# TORONTO STAFF REPORT

Subject: Final Report - Request to Lift the 'H' Holding Symbol from Humber Bay Shores (Motel Strip) By-law No. 1994-197 and Site Plan Approval  
1387585 Ontario Limited and Newport Beach Development Inc.  
2095 Lake Shore Boulevard West  
File Number: CMB20000008  
(Lakeshore-Queensway)

**Site Plan**

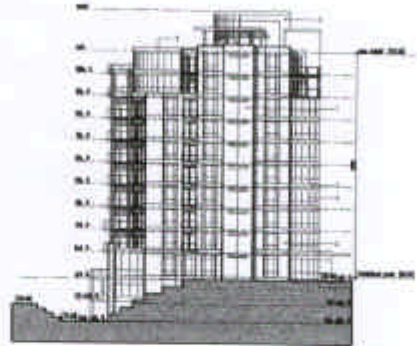
Staff have advised the applicant that all activities relating to servicing should be located within Right-of-way C. This matter will be resolved in conjunction with Works and Emergency Services and prior to site plan approval. It is the preference of staff that access be taken from Right-of-way A1 (the vehicular and pedestrian connection between Lake Shore Boulevard West and Waterfront Drive located north of the site). However, in this case the site is landlocked, with the Cruise Motel located north of the site. Access is therefore being proposed from Lake Shore Boulevard West. Works and Emergency Services will review the location of the access prior to the lifting of the 'H' Holding symbol. A detailed assessment of the built form guidelines relative to Right-of-way C is provided in Appendix 5 of this report.

- (6) Submission of a revised site plan to the satisfaction of Urban Development Services which provides for; servicing/loading functions to be located within Right-of-way C, public sidewalk, and a transition area between the terraces of the ten storey and the public parkland.

The proposed development provides for the required 20 metre Right-of-Way C. Whereas The Guidelines require all activity relating to the servicing of developments be contained within this Right-of-Way, this application proposes servicing to a structure adjacent to the proposed condominium tower on Lake Shore Boulevard. The application should be revised to show all servicing / loading functions located within the designated boundaries of Right-of-Way C and away from Lake Shore Boulevard West. In addition, along the east side of Right-of-Way C, the sidewalk currently shown should be widened to 2 metres and extended north around the northwest corner of the 10-storey tower to the limits of the
